SERVICE TIPS

82-20

GAME: QIX, KRAM, THE ELECTRIC YOYO, SPACE DUNGEON

SUBJECT: SWITCH TEST

FIGURE 1

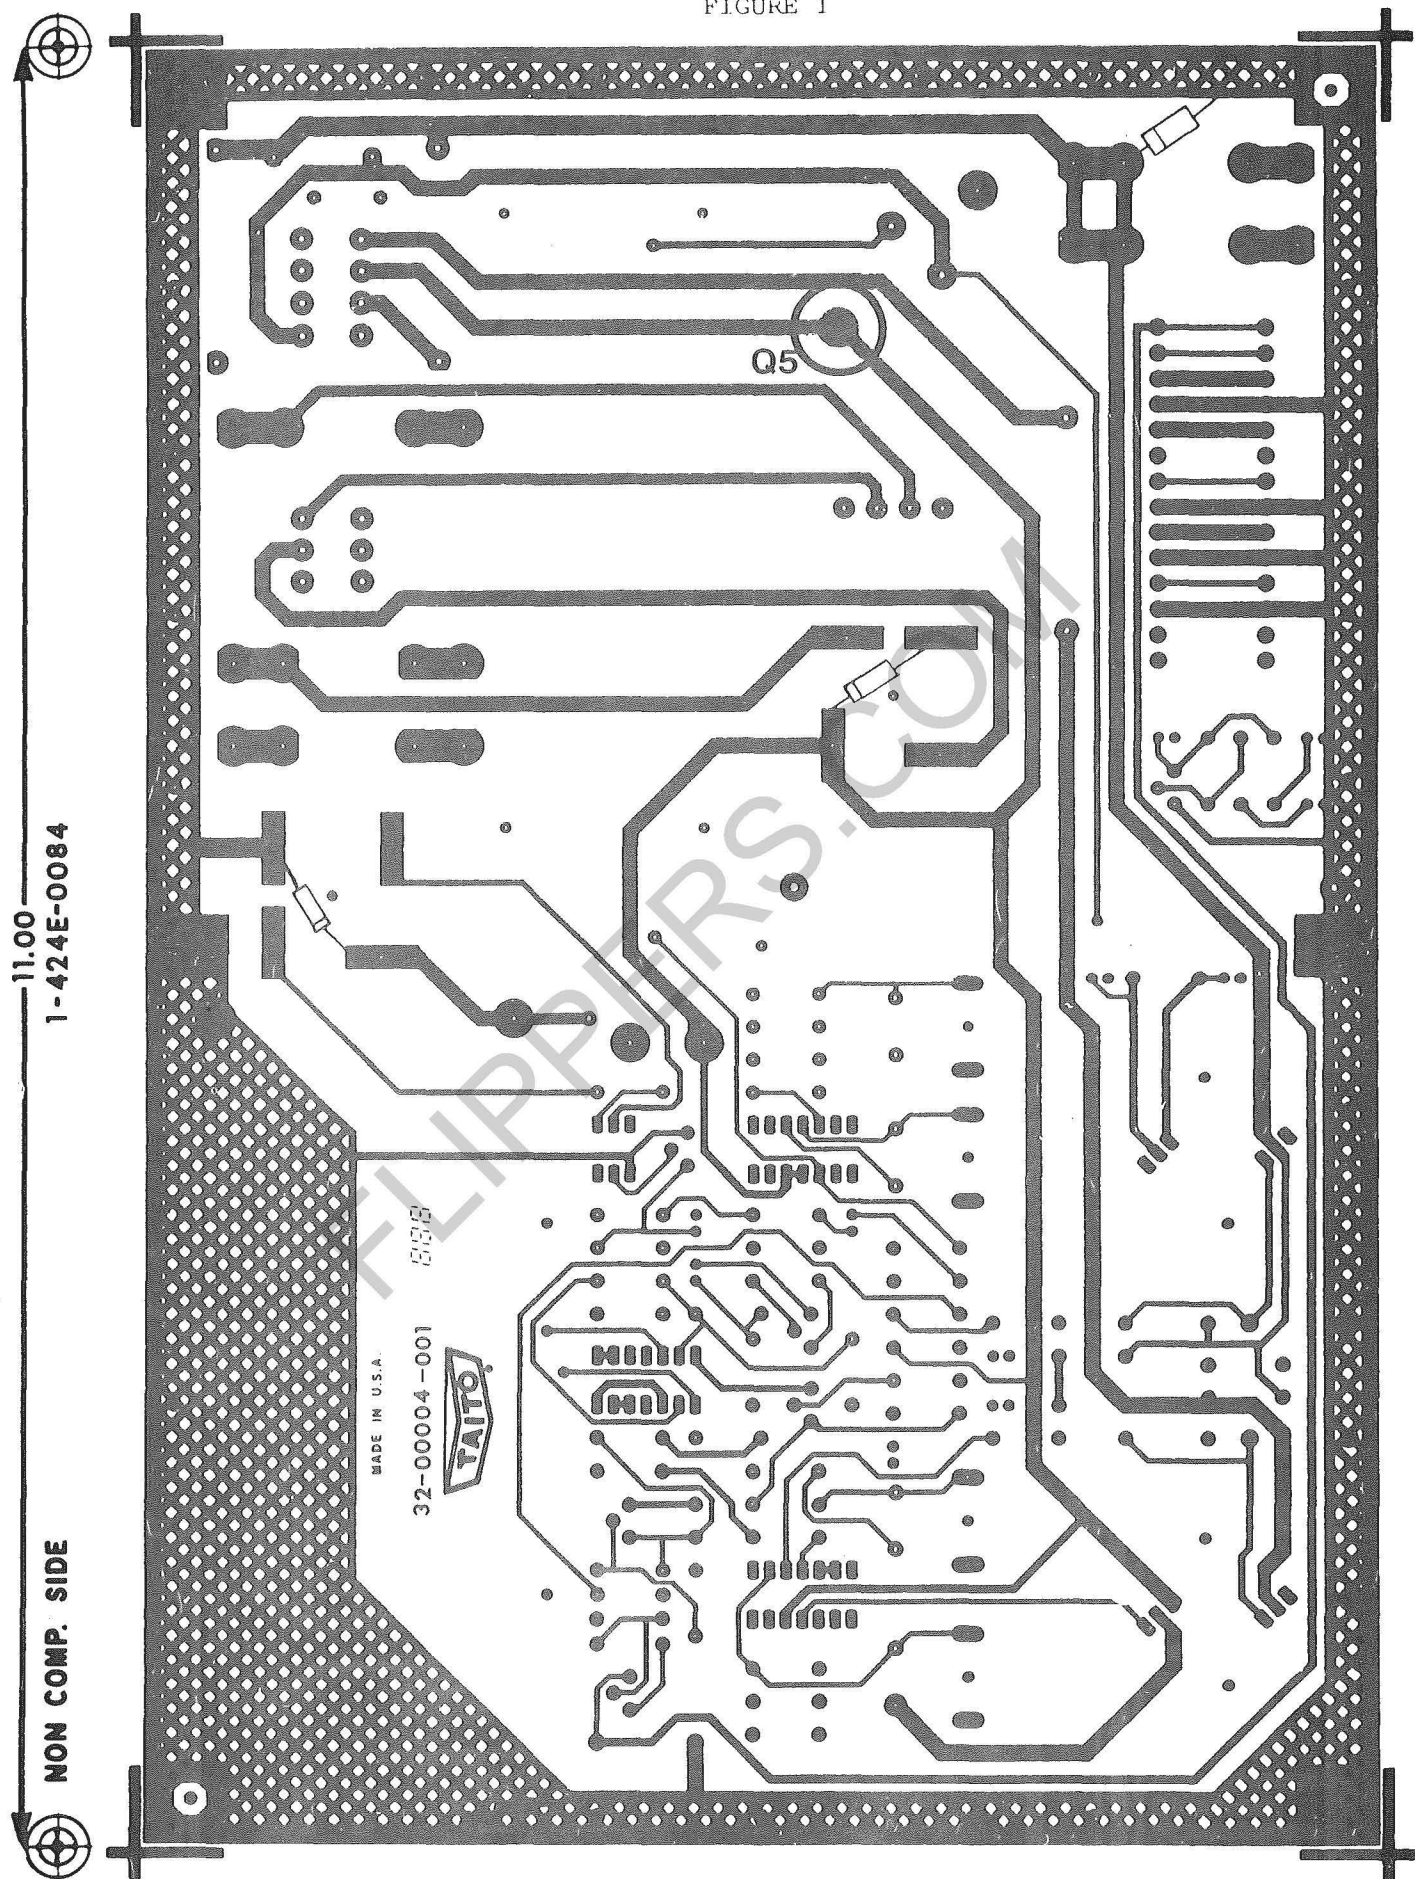
PROCEDURE: REMOVE THE TWO NUTS AND BOLTS HOLDING DOWN Q5. ON THE ETCH
SIDE OF THE BOARD (REFER TO FIGURE 1), SCRAPE THE GREEN SOLDER
RESIST OVER THE FOIL AROUND THE SCREW PAD FOR Q5. WET THE
PAD WITH SOLDER TO MAKE SURE THAT ALL SOLDER RESIST MATERIAL
IS REMOVED. REPLACE NUTS AND BOLTS FOR Q5.

FIGURE 1

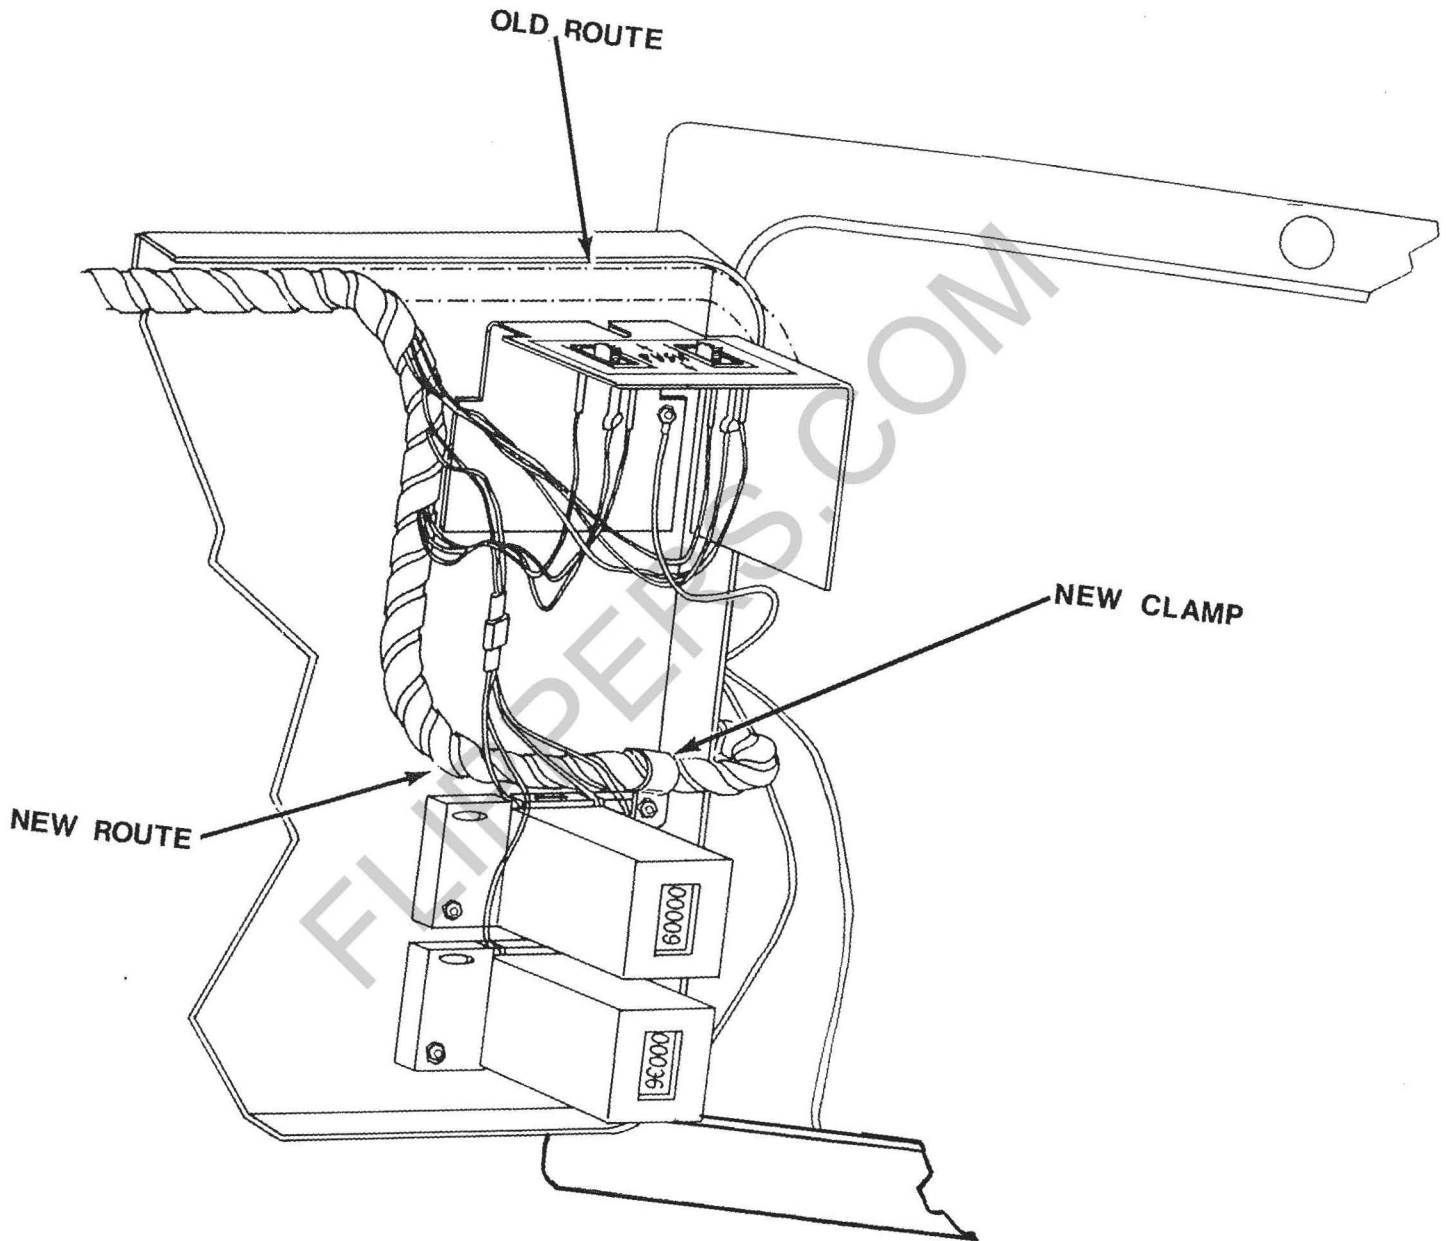
2. RE-ROUTE CABLE ON COIN DOOR AS FOLLOWS: (SEE FIG. 1)

- A. SNIP WIRE TIE THAT HOLDS FLEXIBLE CABLE TO COIN DOOR (ABOVE SERVICE SWITCH BRACKET).

- B. RE-ROUTE CABLE TO THE LEFT OF AND UNDER THE SERVICE SWITCH BRACKET.
 - C. REMOVE UPPER RIGHT NUT FROM THE TOP COIN COUNTER.
 - D. REINSTALL NUT TRAPPING SMALL CABLE CLAMP (59-00004-004) AROUND COIN DOOR CABLE ON COIN COUNTER SO THE CABLE IS NOW POSITIONED HALF-WAY DOWN THE COIN DOOR HINGE.
3. REINSTALL CABLES AS FOLLOWS: (SEE FIG. 2)
- A. REMOVE LOWER RIGHT SCREW ON INTERLOCK ASSEMBLY COVER.
 - B. REINSTALL SCREW, ANCHORING PREVIOUSLY REMOVED CABLE CLAMP AROUND COIN DOOR CABLE.
 - C. RECONNECT MOLDED CONNENCTORS FOR COIN DOOR CABLE.
 - D. VERIFY THAT CABLE FREELY MOVES THROUGH CABLE CLAMP UNDER INTERLOCK ASSEMBLY COVER, TO PREVENT PINCHING THE CABLE.

FIGURE 1

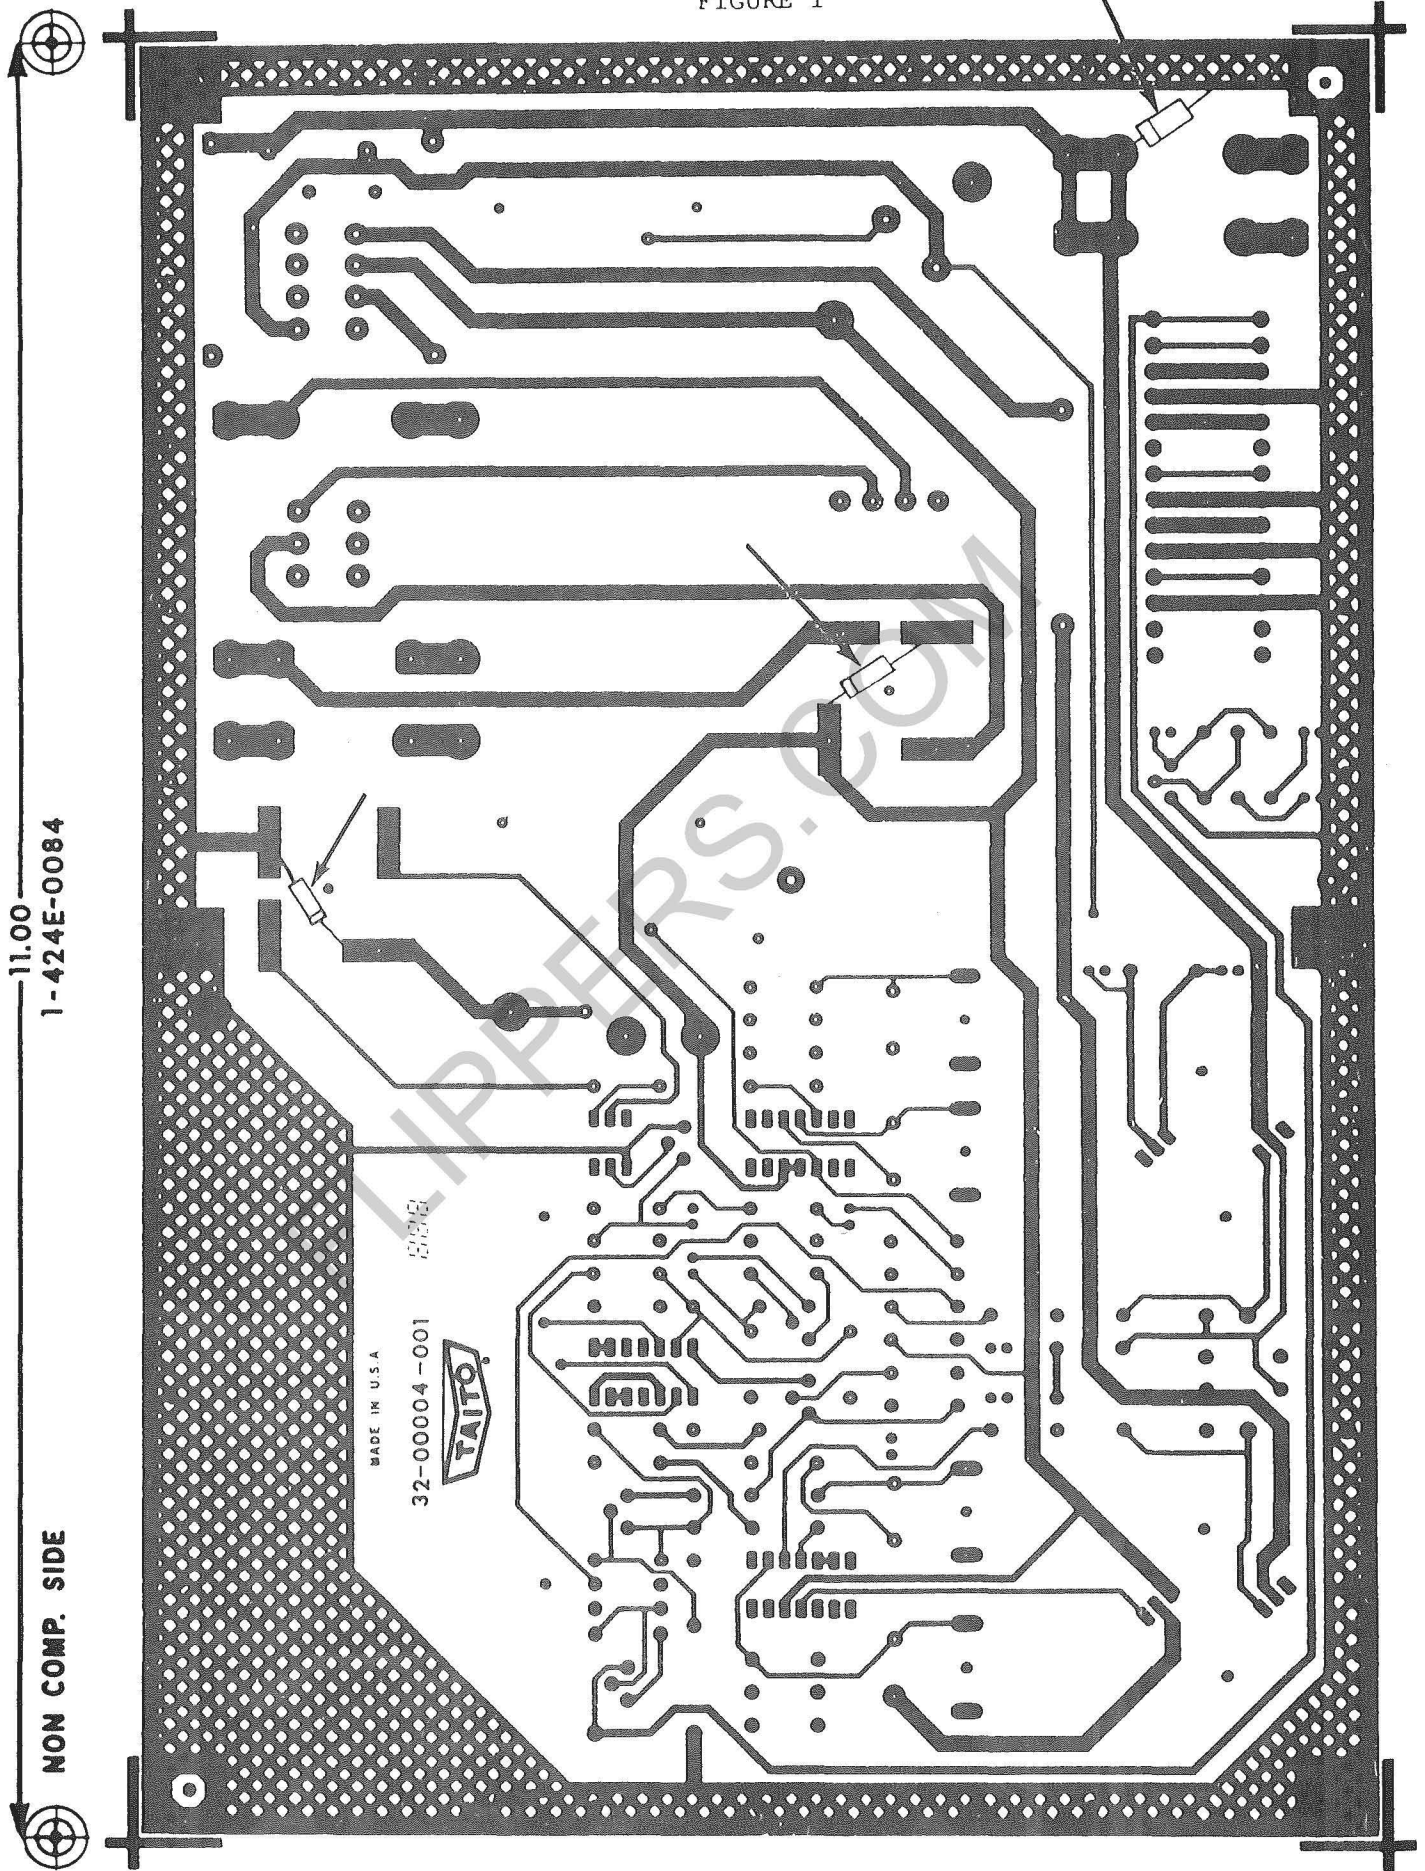
THERE ARE COMPONENTS UNDER THE POWER SUPPLY THAT LOOK LIKE DIODES (REFER TO FIGURE 1 AND 2)(ON ISS. "C" OF THE POWER SUPPLY THEY ARE CALLED D13, D14, D17 AND ARE ON THE COMPONENT SIDE). THESE COMPONENTS ARE CALLED TRANSORBS. THEY ARE USED TO COMPENSATE FOR FLUCTUATING A.C. LINE VOLTAGES. MEASURING THEM OUT OF CIRCUIT, OTHER THAN CHECKING FOR SHORTS, IS USELESS. THE ONLY WAY TO TEST THEM IS TO TAKE THEM OUT OF CIRCUIT, AND THEN POWER UP THE POWER SUPPLY WITH A LOAD. IF THE VOLTAGE, AFTER ADJUSTMENT, IS CORRECT, THEN THE TRANSORB NEEDS TO BE REPLACED.

FIGURE 2

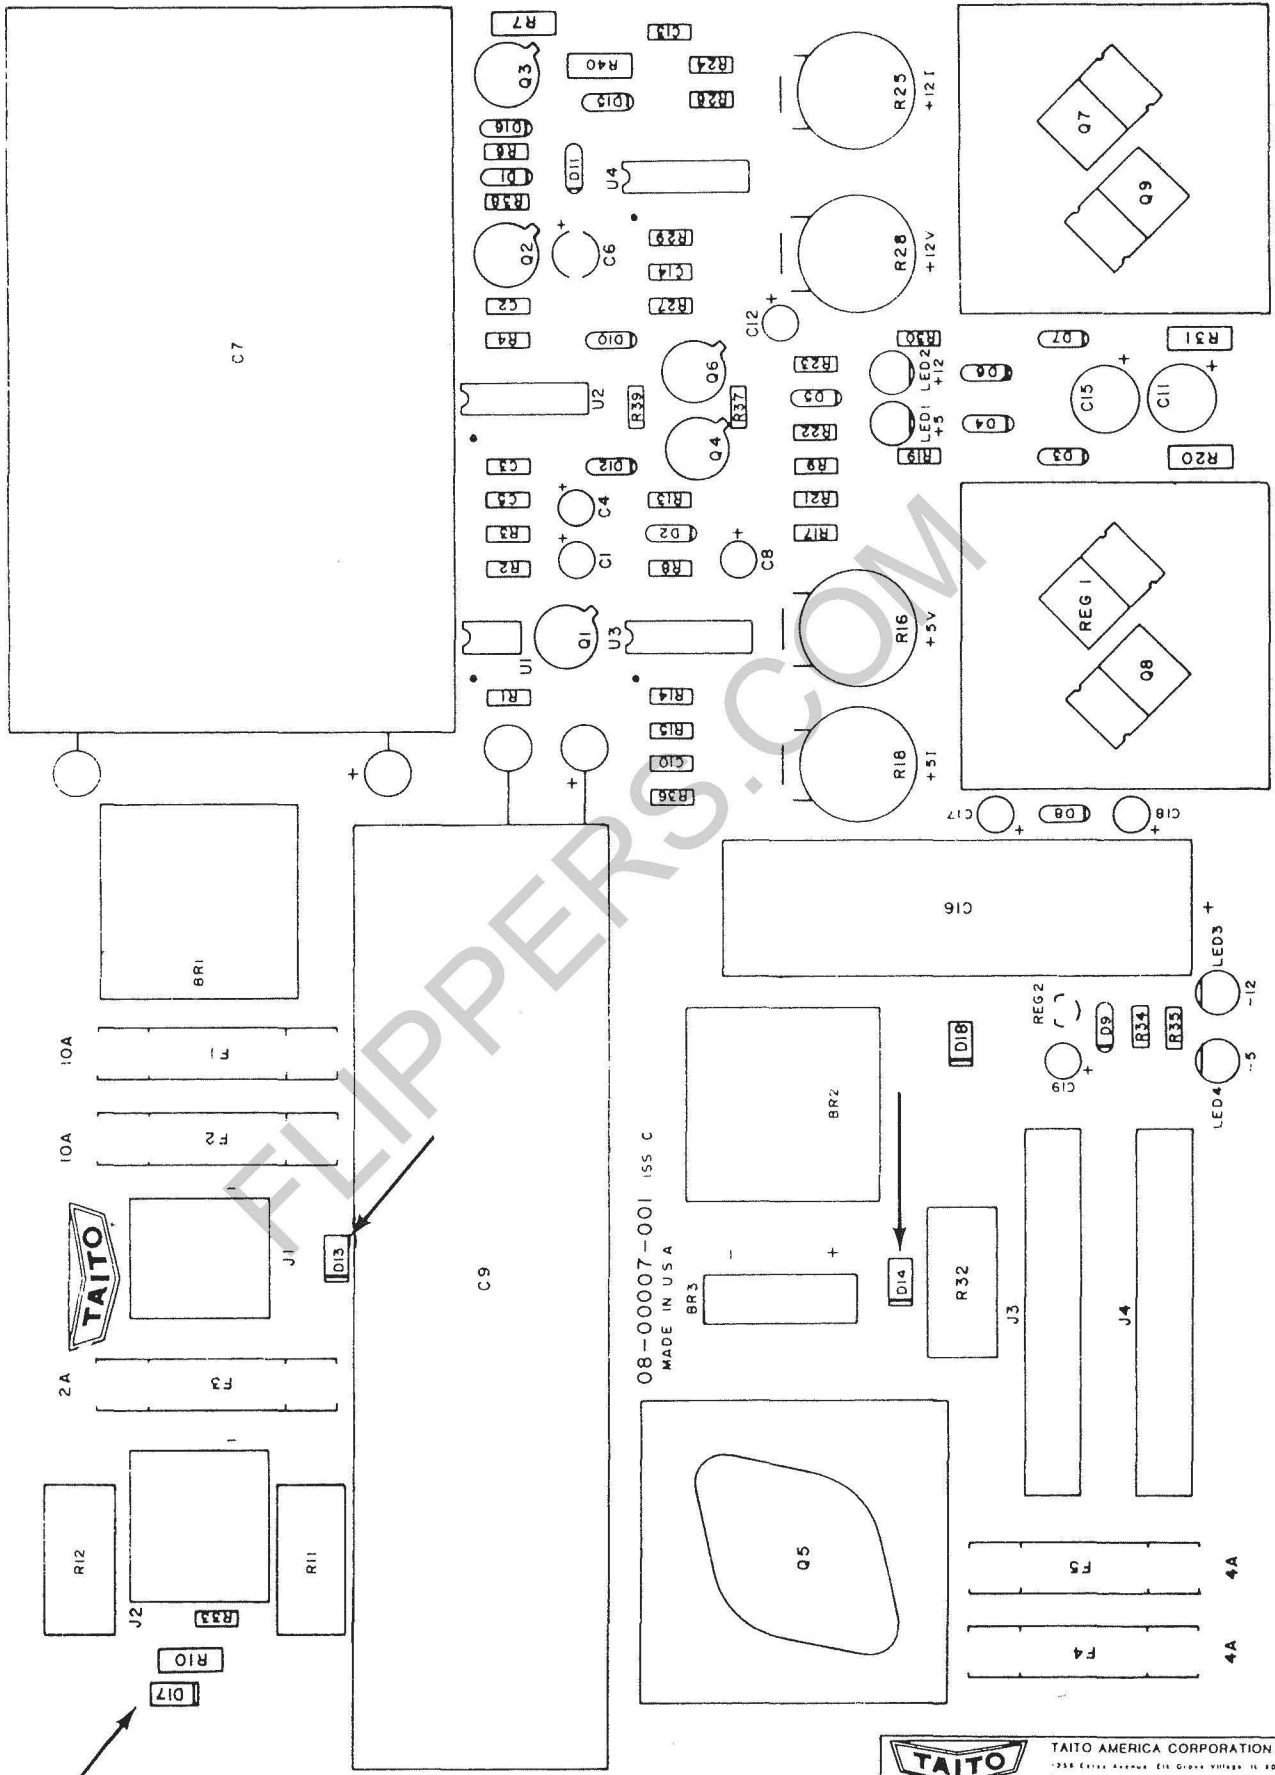
ENSURE THAT THE SCREWS ON C7 AND C9 (REFER TO FIGURE 2) ARE TIGHT. AFTER THE SCREWS ARE TIGHT, MEASURE, WITH THE METER IN AC VOLTAGE MODE, THE OUTPUT OF +5V. THE RIPPLE SHOULD BE LESS THAN A QUARTER OF A VOLT (0.25 V). IF NOT, C7 COULD BE THE PROBLEM.

IF THE +5 VOLTS OUTPUT IS LESS THAN 0.7 VOLTS, MEASURE THE PLUS SIDE OF C7. THERE SHOULD BE AT LEAST +10 VOLTS D.C. IF IT IS LESS THAN 10 VOLTS, THEN ONE OF SIX THINGS COULD BE WRONG:

- 1) F1 IS BLOWN.
- 2) A.C. INPUT BETWEEN J1 PIN 1 & 2 IS LESS THAN 10 VOLTS AC.
- 3) BR1 IS WEAK.
- 4) THE TRANSORB FOR BR1 IS WEAK.
- 5) C8 IS SHORTED.
- 6) C7 IS SHORTED.
